Intel[®] 82801BA I/O Controller Hub 2 (ICH2) and Intel[®] 82801BAM I/O Controller Hub 2 Mobile (ICH2-M)

Specification Update

Document Number: 298242-027

16. Corrections to Section 5.1.4 SERR# Functionality

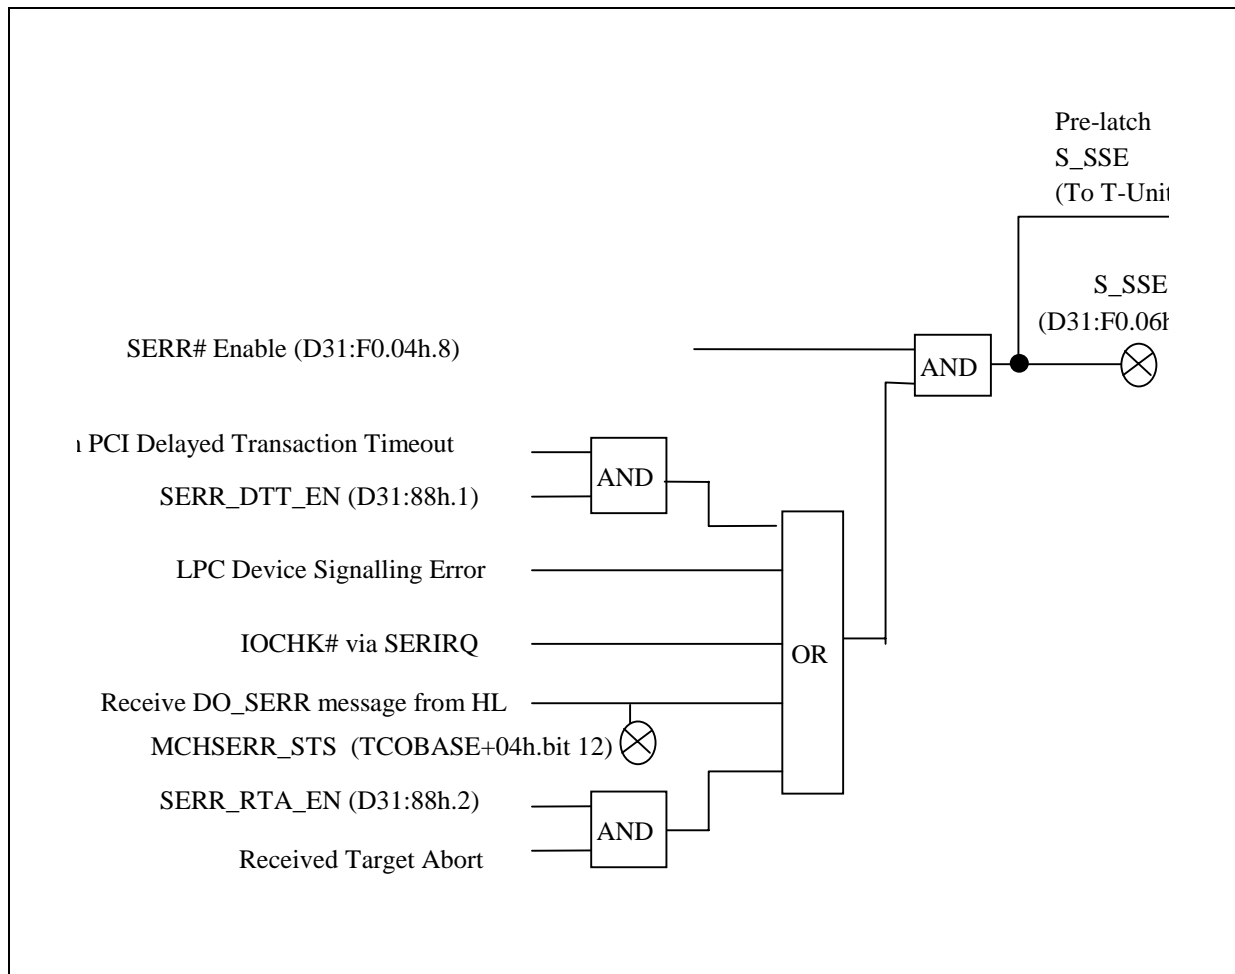
The following note is added just below Figure 5-3: “D30:F0;1Eh:[14] (SEC_STS:[SSE]) is only set when SERR# is detected asserted. Additionally, Figure 5-2, *Secondary Status Register Error Reporting Logic*, is replaced with the figure below:

28. Change to Package Information

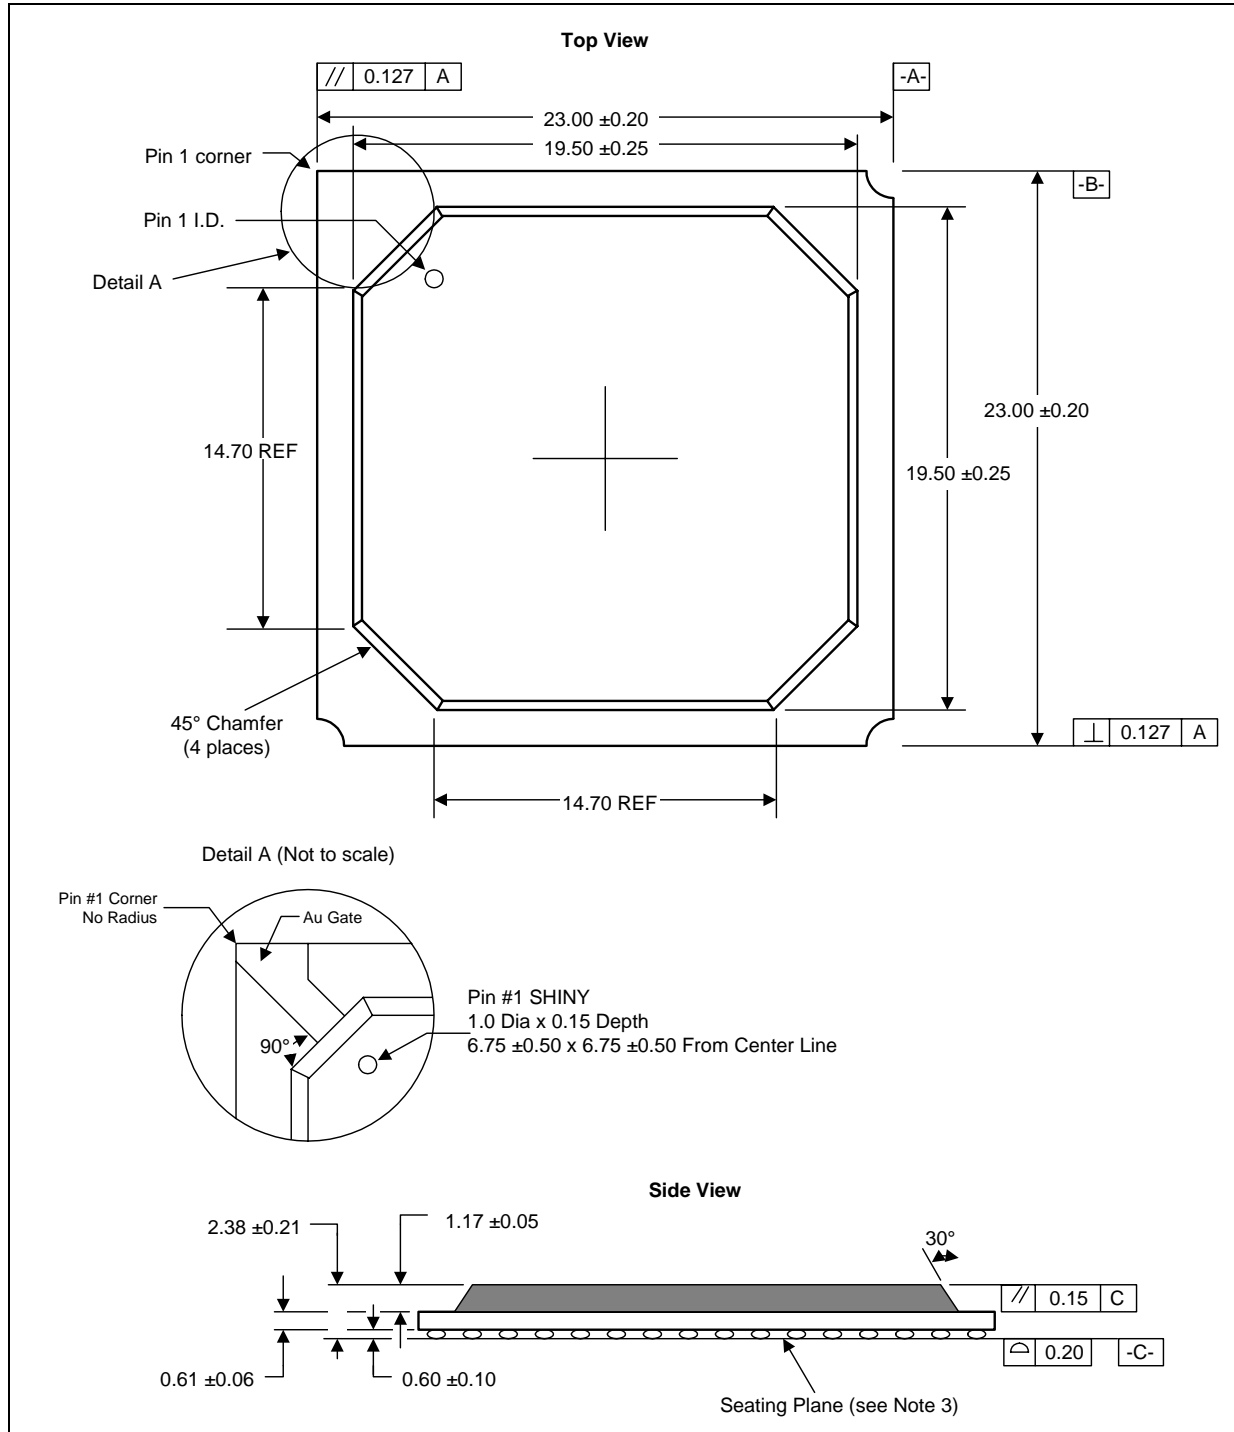
Figure 15-3 is replaced with the figure below.

1. All dimensions are in millimeters.
2. All dimensions and tolerances conform to ANSI Y14.5M - 1982.
3. Primary Datum (-C-) and seating plane are defined by the spherical crowns of the solder balls.
